**Economic Commission for Europe****Inland Transport Committee****World Forum for Harmonization of Vehicle Regulations****Working Party on Passive Safety Provisions****Seventieth session**

**UN Regulation No. 22 (Protective helmets)****Proposal for Supplement 2 to the 06 series of amendments to  
UN Regulation No. 22 (Protective helmets)****Submitted by the experts of the Ad Hoc Group on Safety Helmets \***

The text reproduced below was prepared by the expert of the Ad Hoc Group on Protective Helmets to allow the fitting of aftermarket accessories on helmets. It is based on and in the same time supersedes ECE/TRANS/WP.29/GRSP/2021/15 and informal documents GRSP-69-26, GRSP-69-32 and GRSP-69-36 presented during the sixty-ninth session of the Working Party on Passive Safety (GRSP). The modifications to the current text of the UN Regulation are marked in bold for new or strikethrough for deleted characters.

### Example of the arrangement of the approval mark for a universal accessory

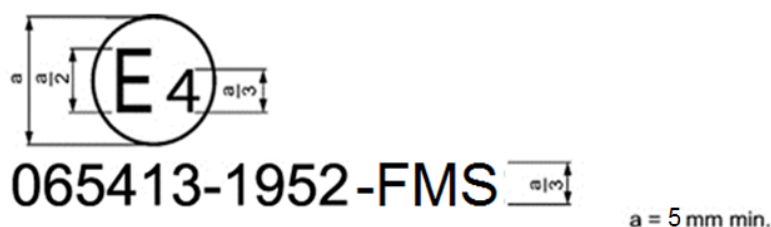
*Insert a new Annex 2C, to read:*

Due to space restrictions, the approval number may be placed on the side of the accessory facing to the helmet provided that the accessory has a support plate and that can be easily detached without any tool for checking.

### Example of the arrangement of the approval mark for a specific accessory

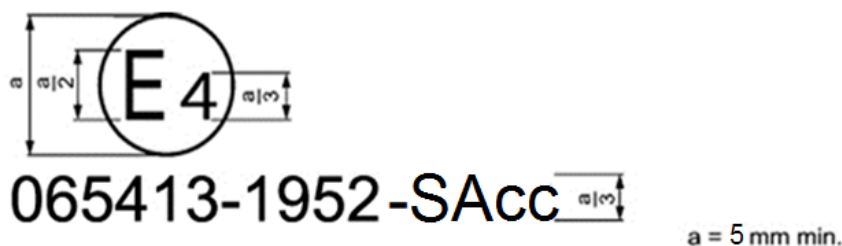
The above approval mark affixed to a specific accessory shows that the specific accessory type concerned has been approved in the Netherlands (E 4) under

"Figure 1d

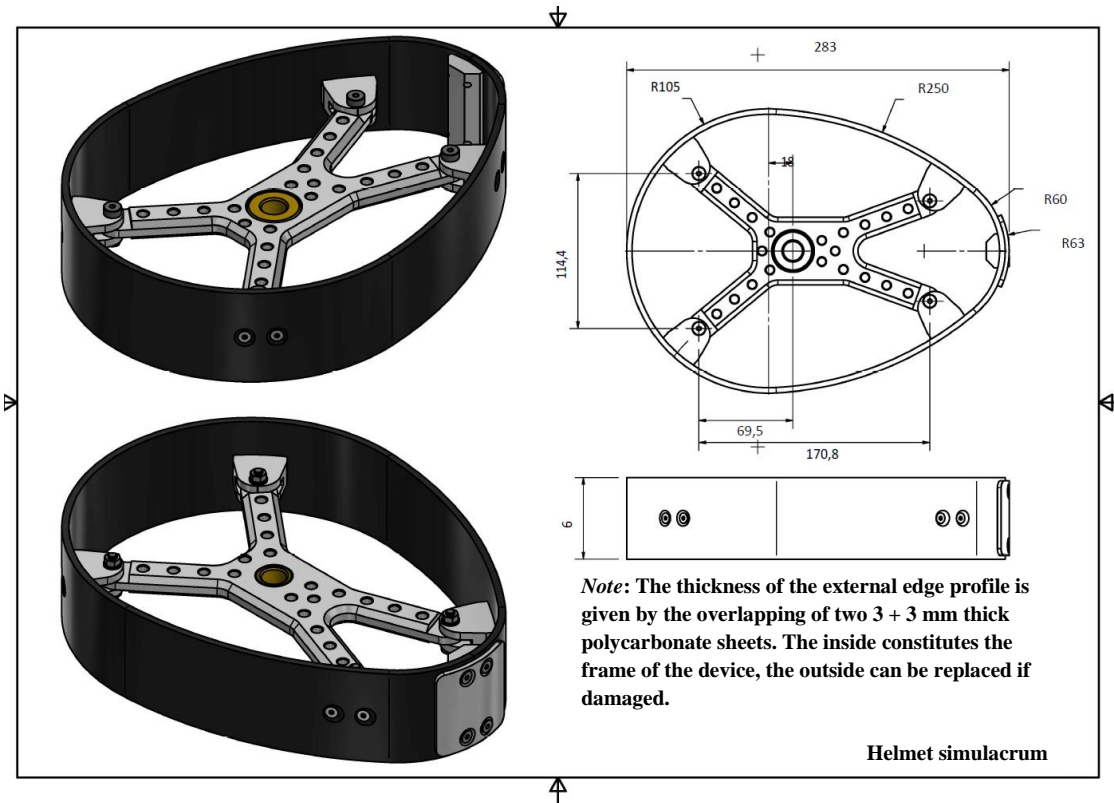
"**7.4.2.1.2.3. The universal accessory and, if it is the case, its support, shall be placed on the helmet simulator defined in Figure 1d of Annex 8 and tested in the worst case as defined by the Technical Service.**"

Annex 8, insert new figure 1d, to read:

**Example of a helmet simulator for accessories projections and surface friction (method B)**

Figure 1

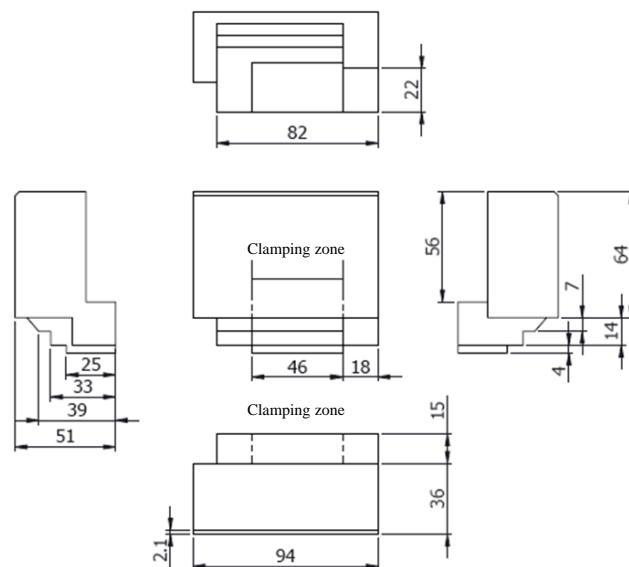
**6.19.7.1. The accessory, or each accessory component if there are more than one, that are to be affixed on the outer helmet shell, shall fit in the fixtures defined in Annex 20 depending on its fitting position.**

**1.1.1. For front mounted accessories:**

Fixture for left front- side mounting (for right side mounting apply symmetry)

Figure 2

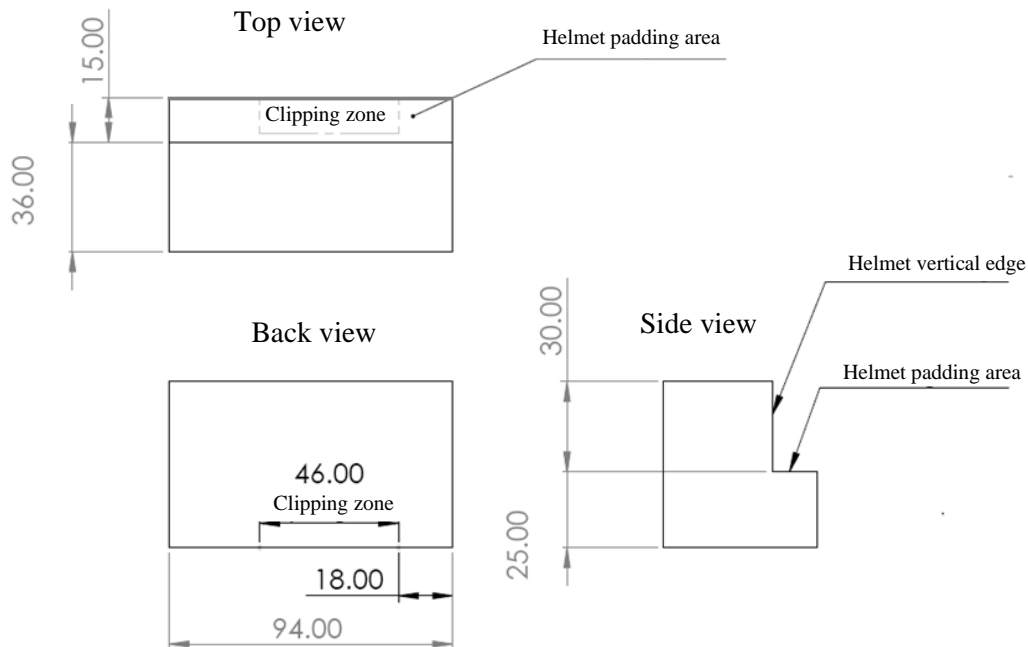
**1.1.2. For side mounting accessories**

**Fixture for left side mounting (for right side mounting apply symmetry)**

Figure 3

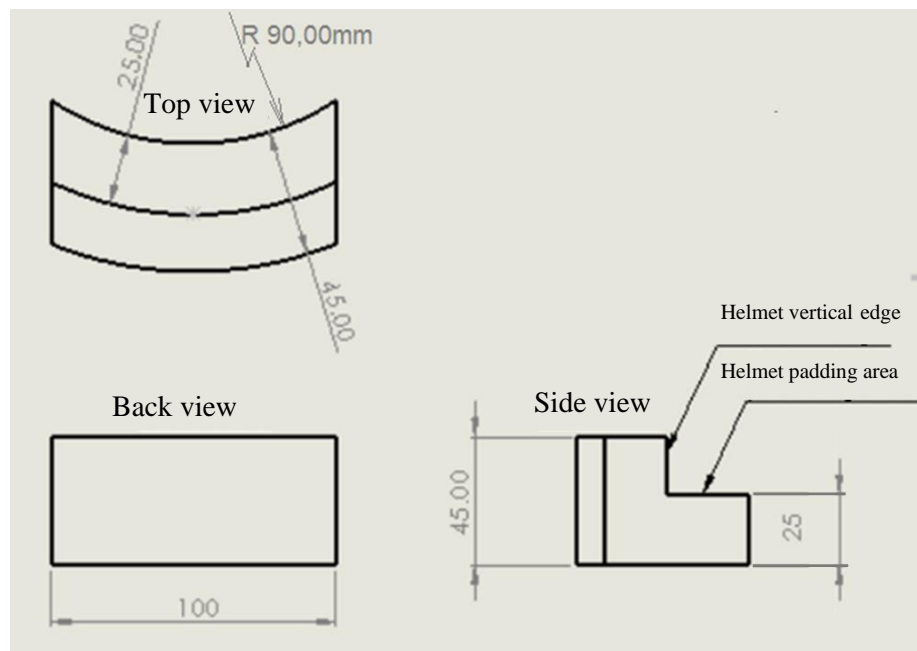
**1.1.3. For rear mounting accessories**

**The rear mounting clamping solution offered by the accessory manufacturer will not invade the impact-affected area unless it fulfils the provisions laid down in this Regulation for those parts entering into the impact affected areas.**

**Figure 4**  
Speakers quasi static crush test corridor

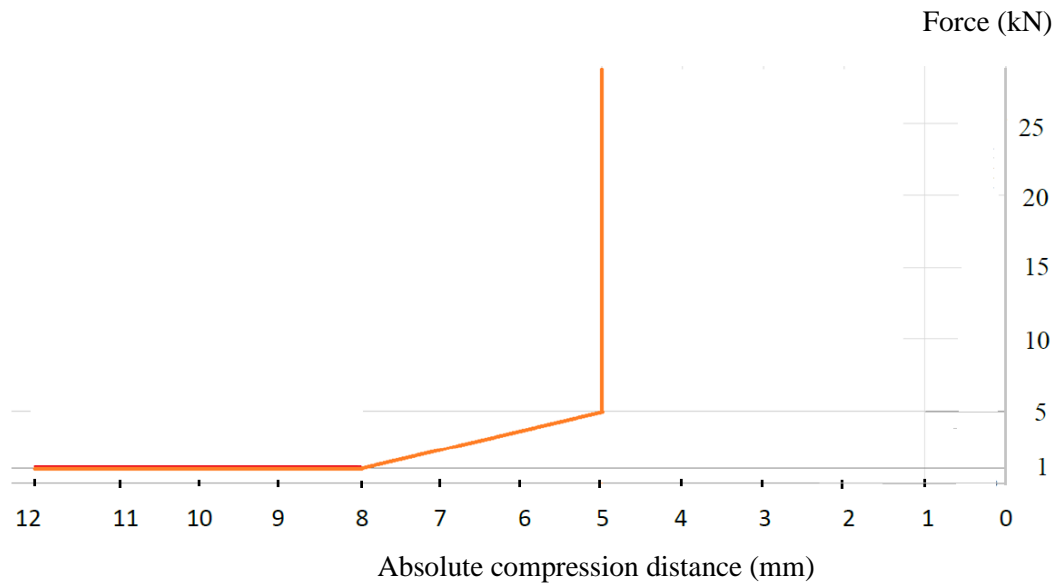
- Measure the distance between the two supports.
- Set the zero displacement setting.
- Start the crush test at a constant speed of 20 mm/min. Record force vs distance at a minimum sampling rate of 10 Hz.

- The test ends when the force reaches 25 kN.
- The obtained chart for the speakers shall fall below the line defining the upper corridor limit.

**Figure 5**  
Thickness vs load

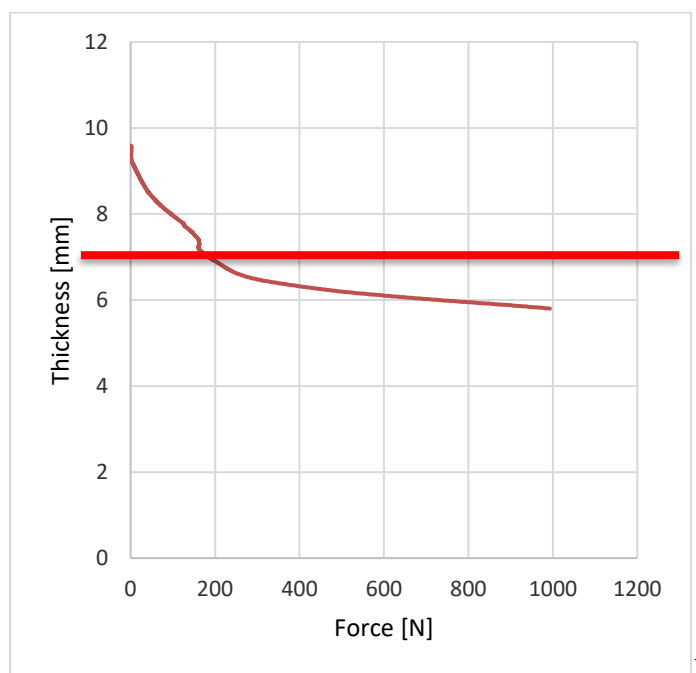
The speaker, with a height more than 8 mm, shall be placed between two parallel plates by means of which a known load can be applied, the surface of the plates shall be large enough to contain a circle of at least 65 mm in diameter. An initial load of 10 N shall be applied, the load shall then be increased at a minimum plates speed of 5 mm/min. until the application of a load of 1,000 N (-0+10N).

3.2.2. The thickness of the speaker subjected to a load of 1,000N (-0+10N) shall be less than 8 mm.

**Figure 6**

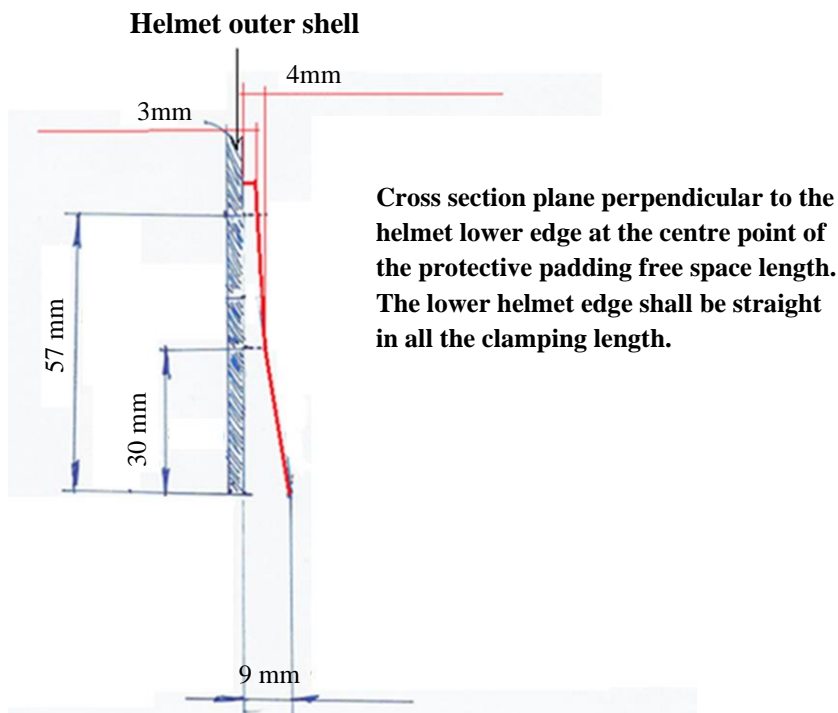
**2.1. The helmet clamping free space dimensions for front and side mounting will be, at least, the following ones:**

**Free protective padding space for accessories clamping for front and side locations of UA helmets**

The length of clamping zone will be according to the fixture drawings.
